**Subject: Wallowa Falls Hydroelectric Project (FERC Project No. P-308)  
Response to Request for Additional Information**

**Subject:   Wallowa Falls Hydroelectric Project (FERC Project No. P-308)**  
**Response to Request for Additional Information**

Figure B-1. Weather Conditions for November 25-December 20, 2013

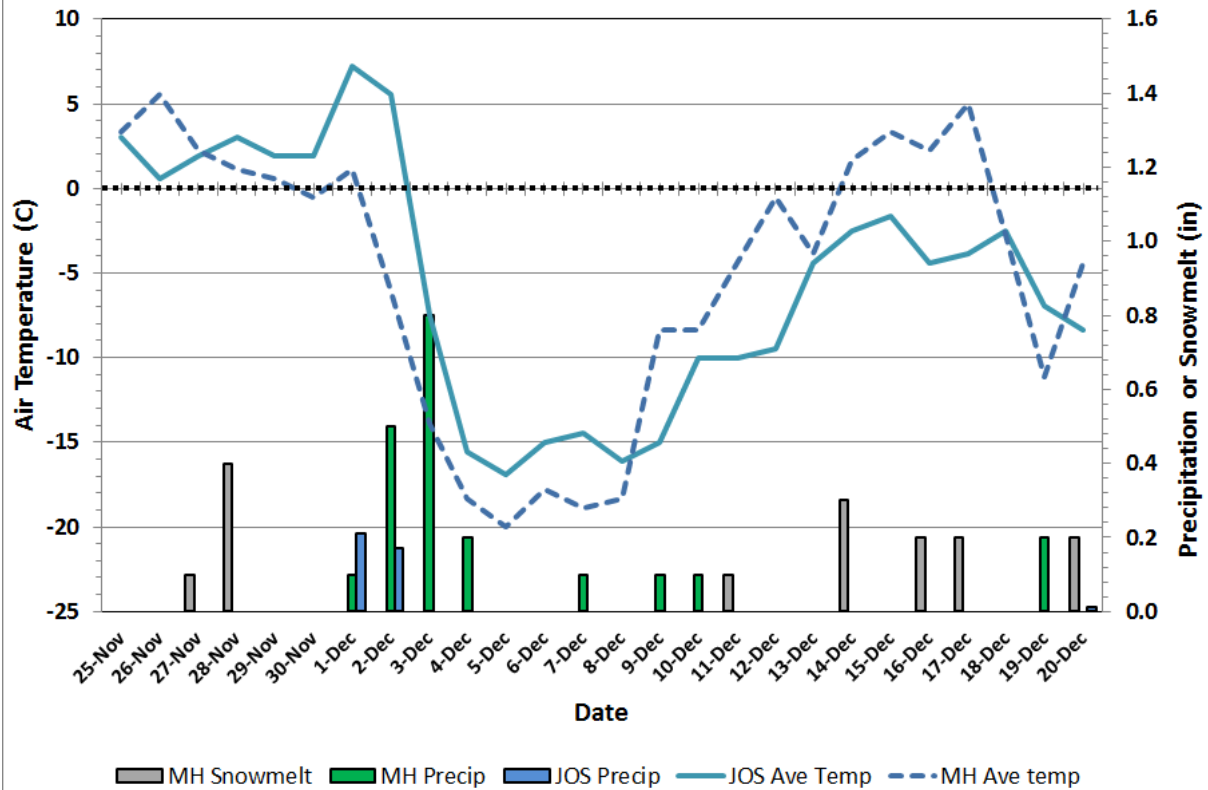
To conduct our analysis of the potential for downstream flooding in the East Fork bypassed reach under existing and proposed operations, we need additional information on project operation and hydrologic conditions during the December 2013 period of channel ice formation. Therefore, please provide the following additional information for the period of December 1 through December 31, 2013:

- a) The weather conditions surrounding the December 2013 event are striking in that very cold conditions developed and prevailed from December 2-14 following quite mild conditions in late November (Figure B-1). Mean daily air temperatures were below freezing (-0°C, 32°F) throughout the period at both the Mt. Howard SNOTEL station and the Joseph Airport. From December 4-8, conditions got very cold – mean daily air temperatures were actually below -18°C (0°F) at Mt Howard and around -15°C (5°F) at Joseph.*

- b) Also, note that the air temperature data indicate that a temperature inversion occurred in the area during about December 8-18 (Figure B-1). During this time, air temperatures at the Joseph airport were consistently colder (by up to several degrees F) than at Mt. Howard. This may be a factor in the duration of freezing water temperature conditions (and presumably ice formation) at the BPL site as discussed further below.*

- c) The precipitation data (columns in Figure 1) indicate that nearly an inch of precipitation fell during December 1-4, 2013. This is a relatively significant amount for this area. However, because air temperatures were rapidly dropping, PacifiCorp suggests that this precipitation, although significant, did not produce significant additional runoff (and increased flow) in the East Fork Wallowa River. This is a factor in interpreting the high flow estimate (of about 125 cfs on December 10) at the BPL gage site as discussed further below.*
